Permit Number: 101454

This is to certify that AVESTA OAK STREET LP / WEIGHT R CONSTRUCTION
has permission to New 4 story, 37 unit apartment building, 1 story includes secure open private parking garage & limited common
AT 72 OAK ST CE 037 A035001
City of Portland

Project Name: Oak Street Lofts
Project ID: 10-99700002
Project Address: 72 Oak St. **CBL:** 037-A-035-001
Planner: Erick Giles, AICP, LEED AP

RESILIENT TERMINATION @ TRANSFER SHOWER

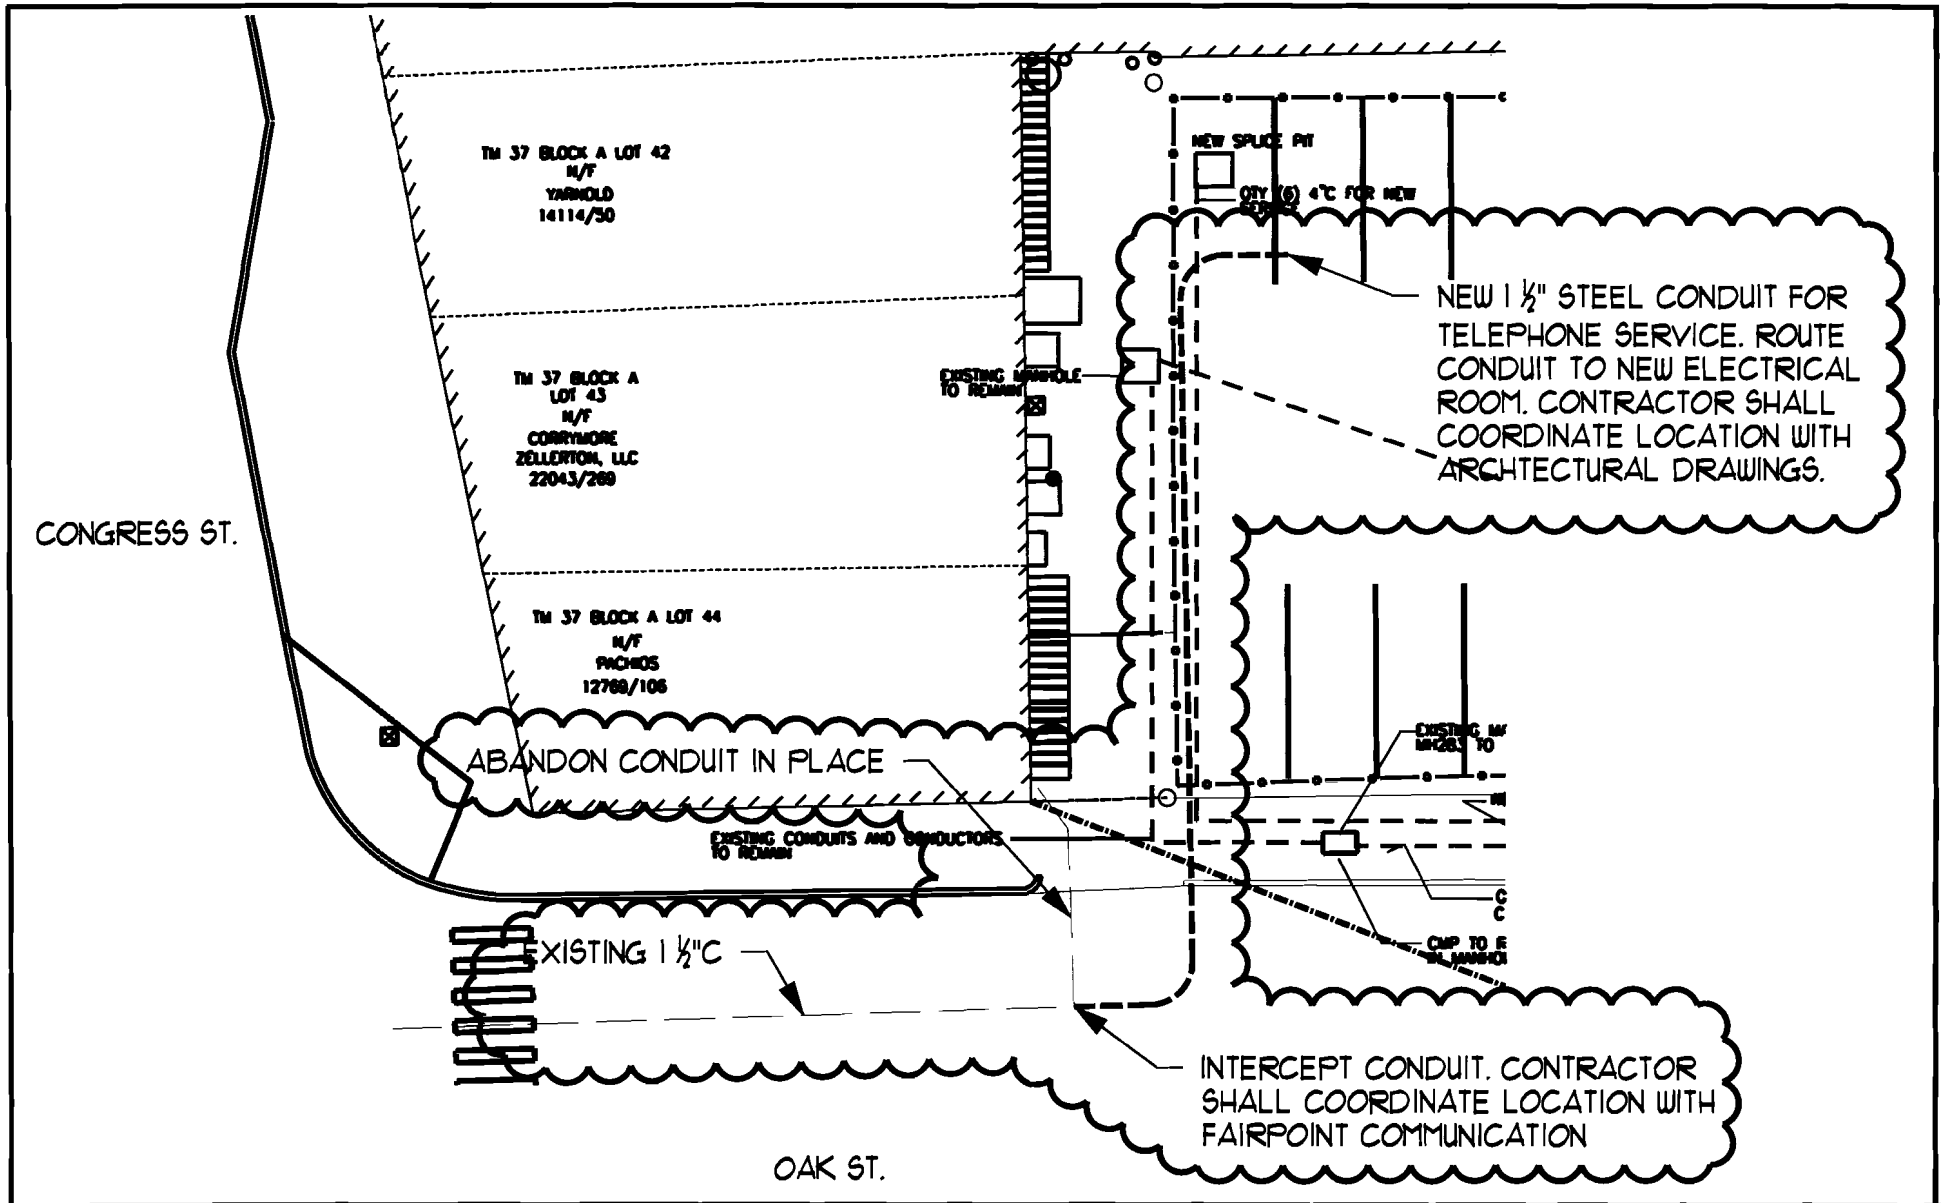
28. On Drawings A 1.8, change all detail reference of flooring transitions at roll in showers to reference Detail 5/A4.13. On Drawings A1.6, A1.7 and A1.9, provide flooring transitions to transfer showers per attached SKA-2 (attached).

C1

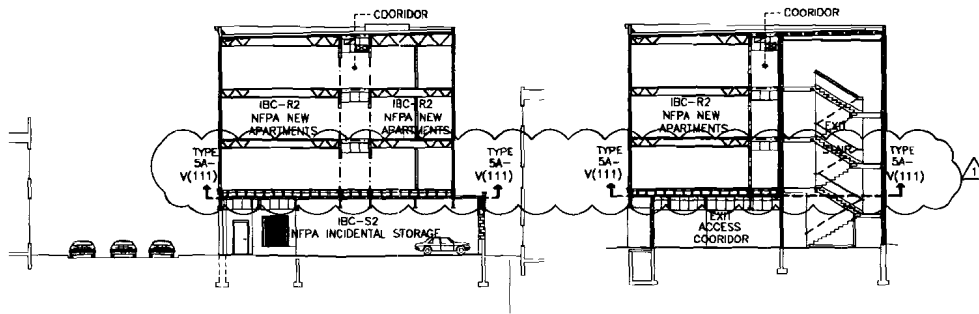
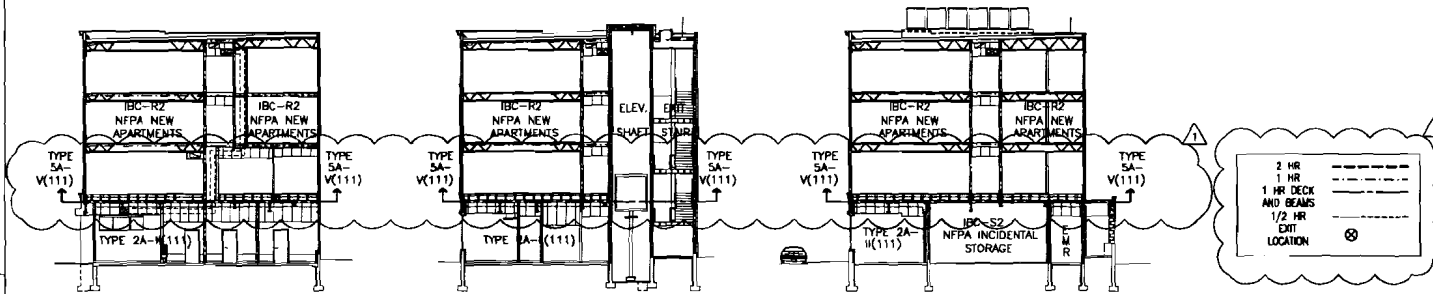
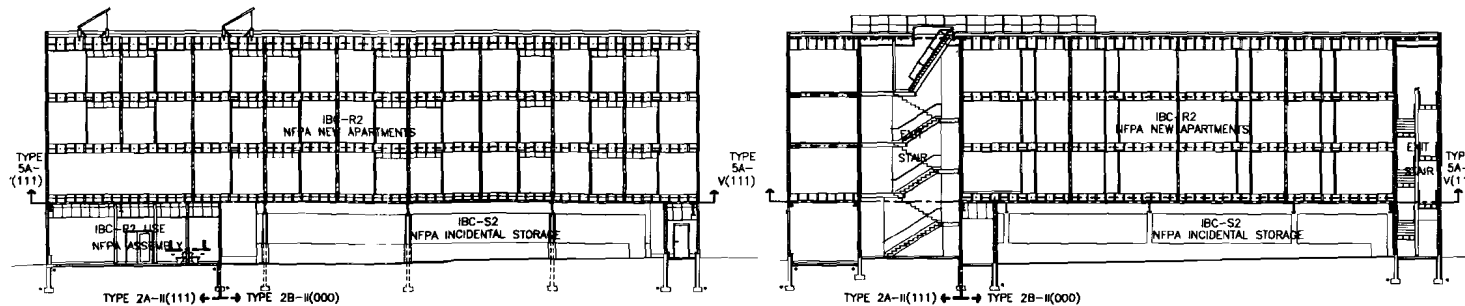
3. Replace Drawing C1 CODE REVIEW PLANS with Drawing C1 CODE REVIEW PLANS Revision 1 dated 3-1-2011. Note that the reprint of this sheet was made at the request of the local Authority Having Jurisdiction and that the actual changes associated with the Drawing replacement were made in Addendum 01.
